KENT STREET SAND PIT

DETAILED DESIGN REPORT

TOWN OF
VICTORIA PARK

The following document outlines the outcomes of the consultation, the Town of Victoria Park responses and the impacts on design.

DETAILED DESIGN PLAN AS ADVERTISED

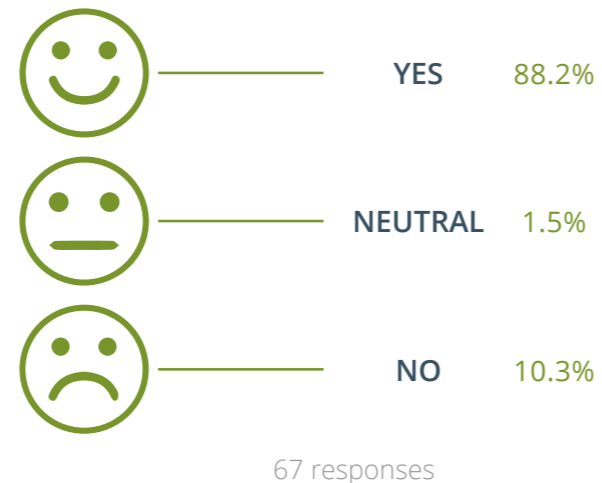
- I am concerned about the possible anti social environment this will encourage
- It's pretty underwhelming and more of the same as what's available in the rest of the bushland precinct. There is nothing outstanding in the design that connects it to the place

- The area should be reinstated as native bushland similar to the Kensington Bushland. Infrastructure should be limited to paths and benches
- Viewing platforms, increased visitors to area of real concern. Especially as we look onto this quiet area apart from its usual bird life

- Wheelchair tyre washing facilities. Response: *These will be considered in an amended design.*
- Details of the accessible wheelchair points. Response: *As above.*
- Tactile ground surface indicators proposed for each ramp. Response: *As above.*
- Compliance of the shared space beside ACROD bay? Response: *As above.*
- Consideration should be given to making the paths 3mtrs wide with an access ramp for 4wd ambulance or fire appliances. Response: *Advice from bushfire consultants informed the design, including pathway width consideration. In the event of a bushfire, firefighters may operate from the road reserve. Primary paths can provide access point and can be limited to 3m. Given the small size of the site, the 3m perimeter path will be sufficient for mobilisation around the sand pit.*
- Inclusive space. Response: *Noted*

- Consideration of a different material than timber for the deck. Metal grating that is accessibility friendly and requires less maintenance in the long term. It also allows the plants to grow underneath so wont disrupt the growth of plants. (option for Traxion, anodised aluminium, Gripmesh material). Response: *Noted. The materiality of the decking will be revised.*

- Raise the height of viewing platform. Response: *These cannot be too high as the height needs to be sensitive to the privacy of the surrounding residents. Height is also set for CPTED purposes and disabled access.*

DESIGN RESPONSES: DETAIL PLAN 1

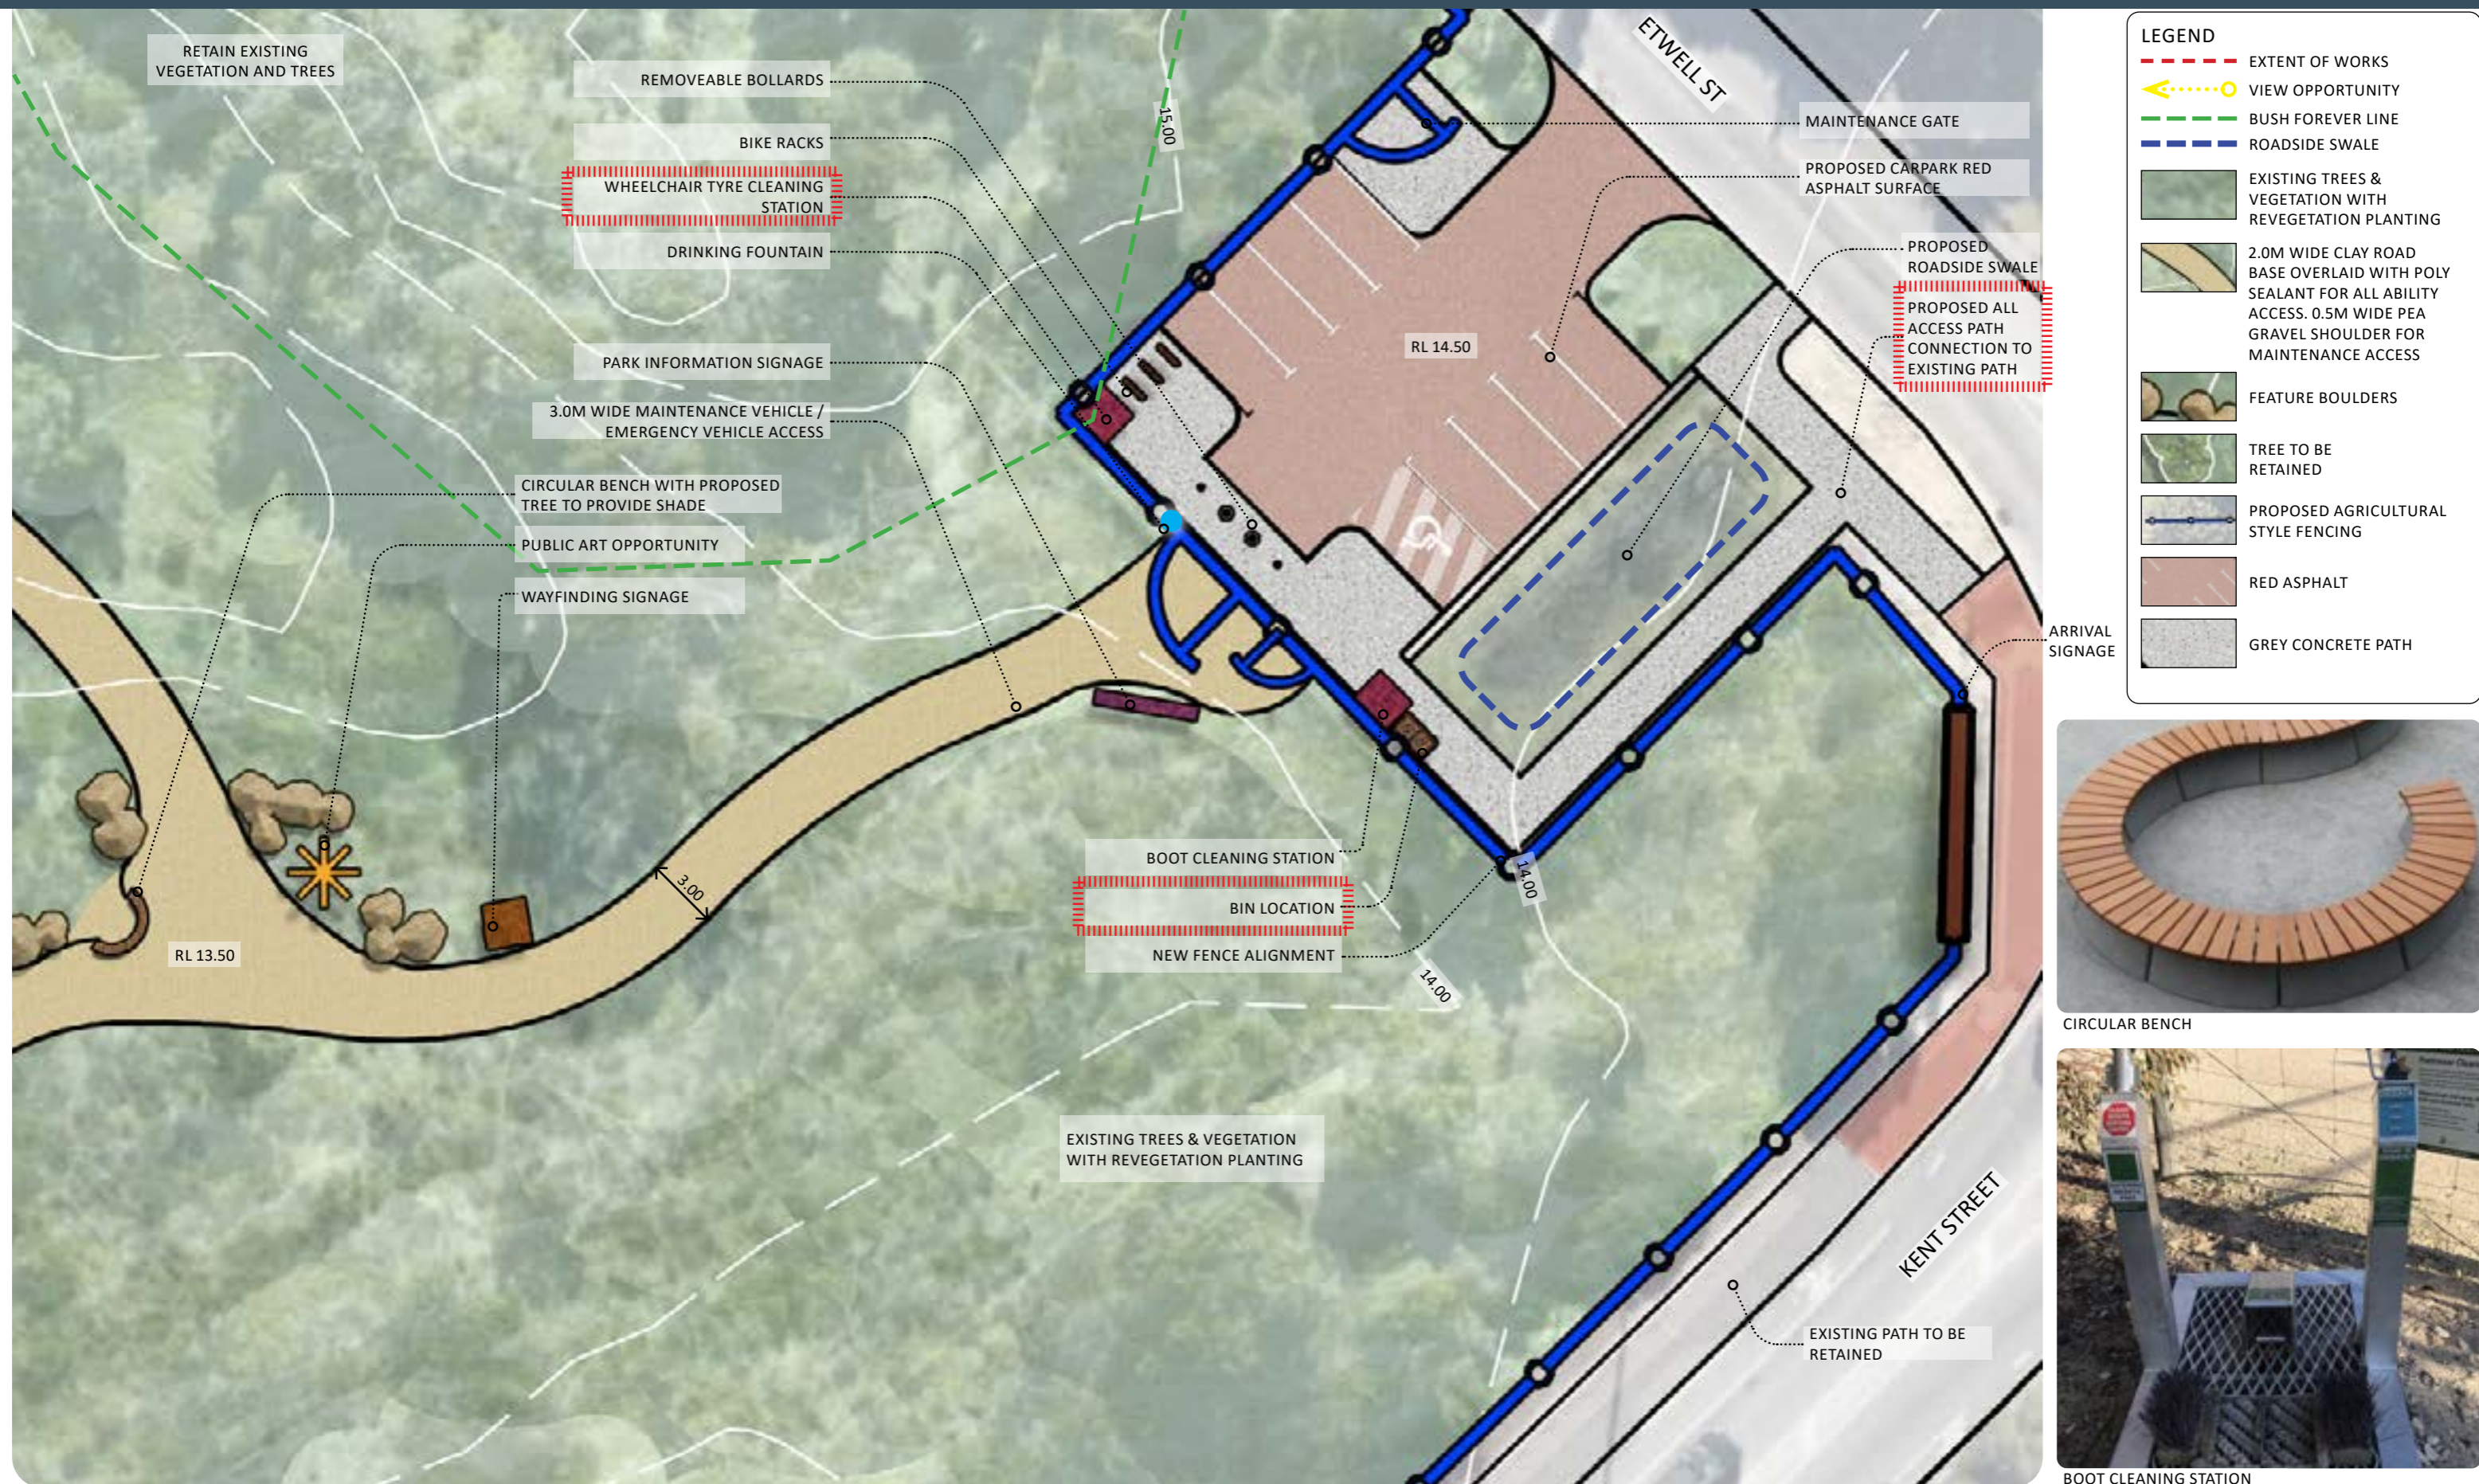
ELEVATED VIEWING DECK WITH BALUSTRADE AND SHELTER. THIS IS ONLY PLATFORM WITH SHELTER.

ELEVATED RAMP WITH BALUSTRADE FOR DISABILITY ACCESS. DEPTH OF FOOTING FOR RAMP WILL NOT INTERFERE WITH CONTAMINATION ZONE (1M DEEP)

DESIGN RESPONSES: DETAIL PLAN 2

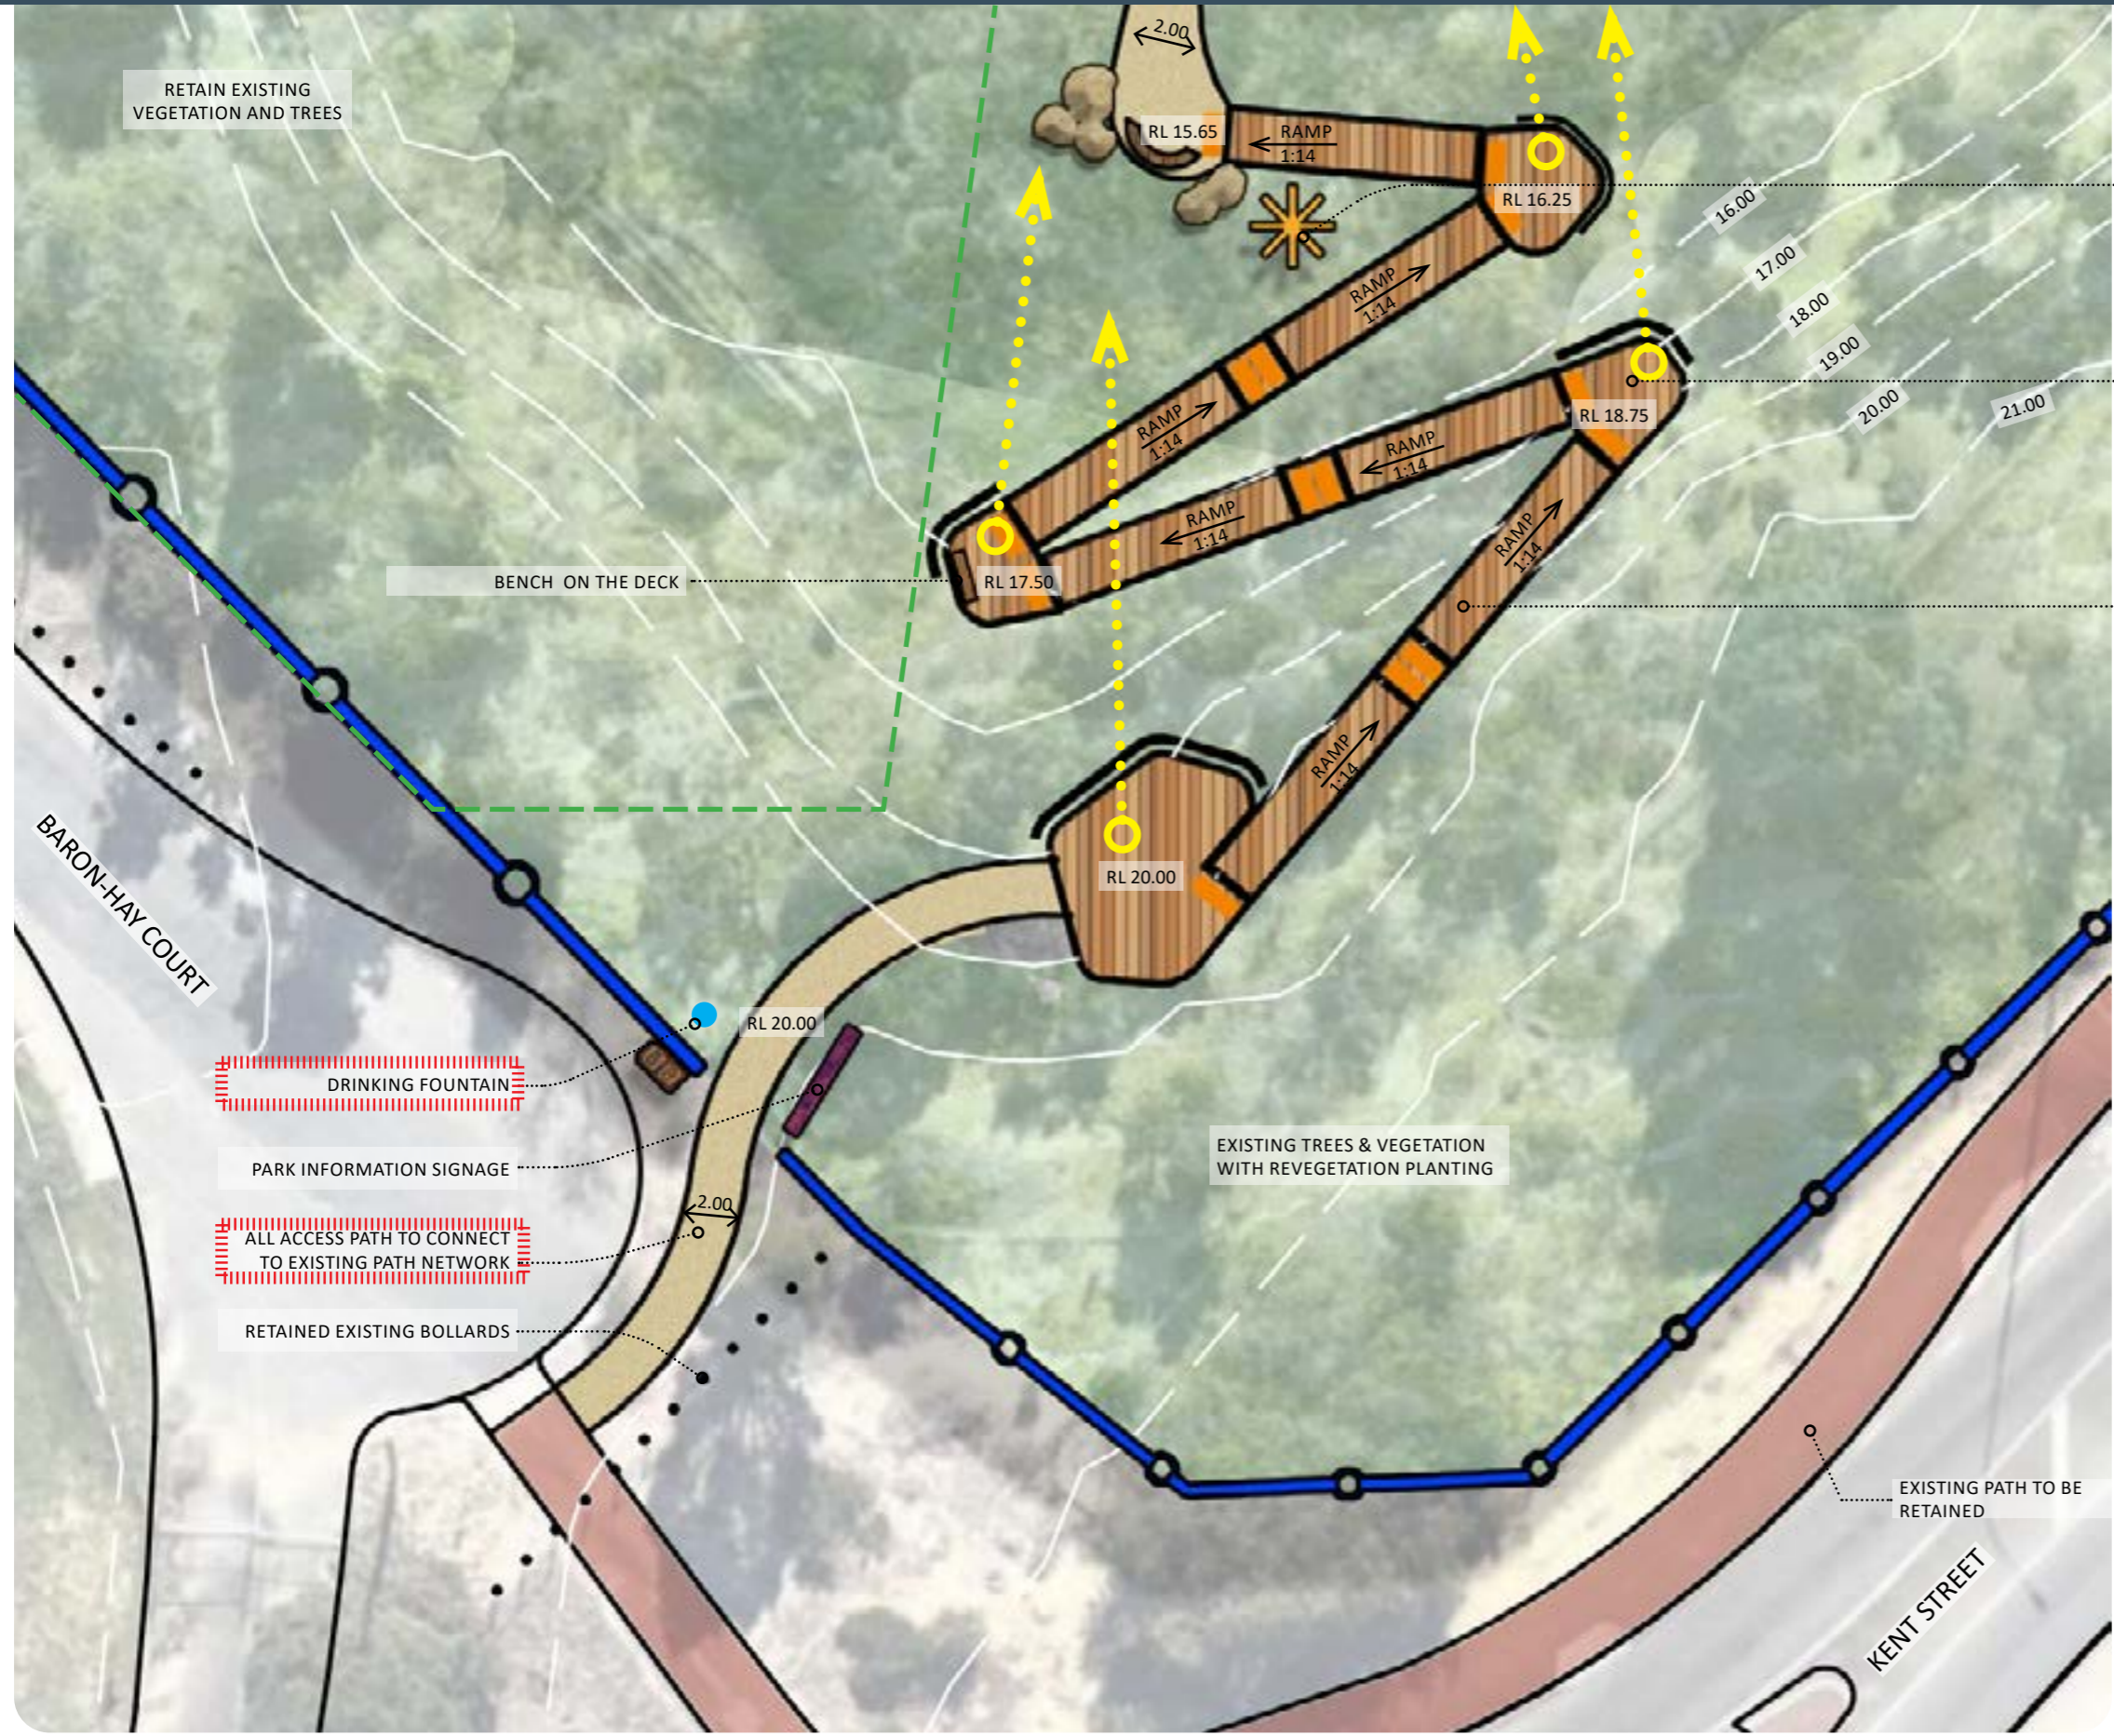
TIMBER VIEWDECK AT THE TOP OF THE RAMP

BOOT CLEANING STATION
